SERVICE BULLETIN

OIL - FUEL COOLED OIL COOLER - INTRODUCTION OF LONGER UPPER BONDING STRAP - CATEGORY CODE 6 - MOD.ENG-79-0020

V2500-ENG-79-0020

Location of bonding strap - Before alteration
Fig.2

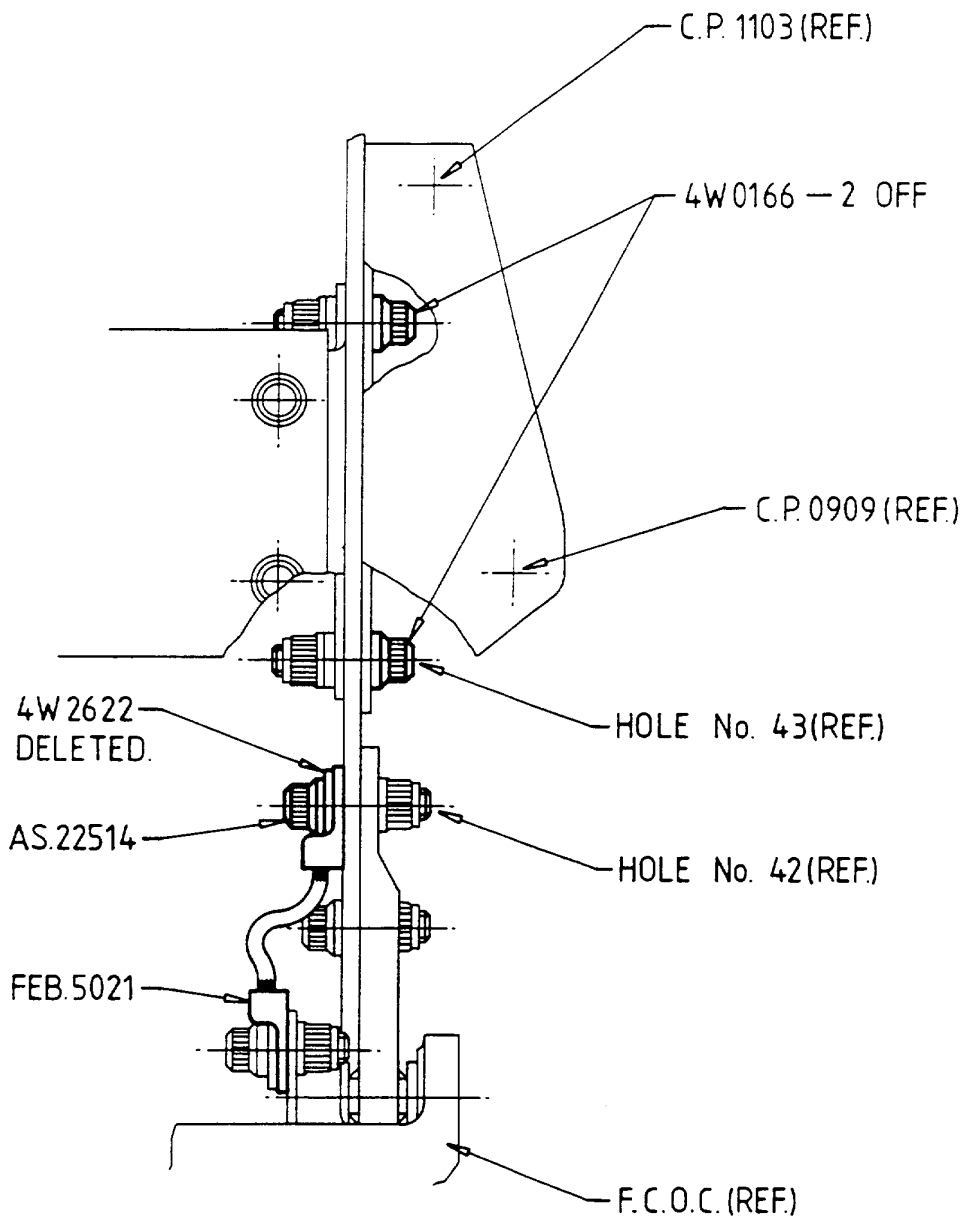
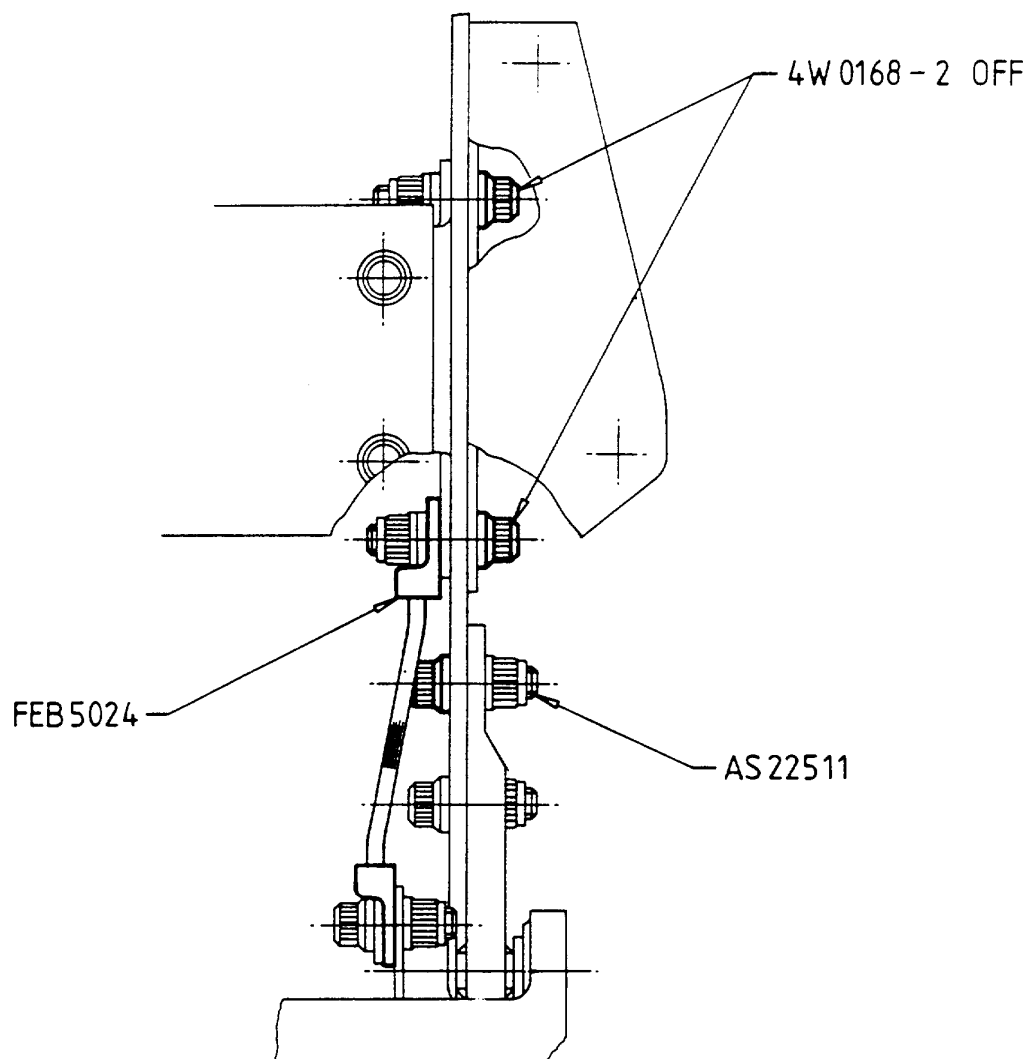
The bonding strap between the top of the fuel cooled oil cooler (F.C.O.C.) and the fan case flanged FB may not to be the proper length and could therefore touch either the adjacent oil tubes or the bolt tail on flange FB, possibly resulting in fretage.

- (a) A longer bonding strap replaces the existing strap. Its position on the F.C.O.C. remains unchanged but it has been moved one bolt position clockwise on flange FB to bolt position 43.
- (b) The bolt at position 43 has been lengthened to accommodate the lead terminal. The bolt at position 44 has also been lengthened to maintain commonality.
- (c) The washer at the existing strap position has been deleted and the bolt at this position has been shortened to compensate for the removal of the washer and bonding strap.

- (1) The new bonding strap FEB5024 introduced by this Service Bulletin is not interchangeable with the existing bonding strap.
- (2) Assemble new bonding strap FEB5024 by use of approved procedures, Engine Manual, 72-00-32 Removal/Installation.
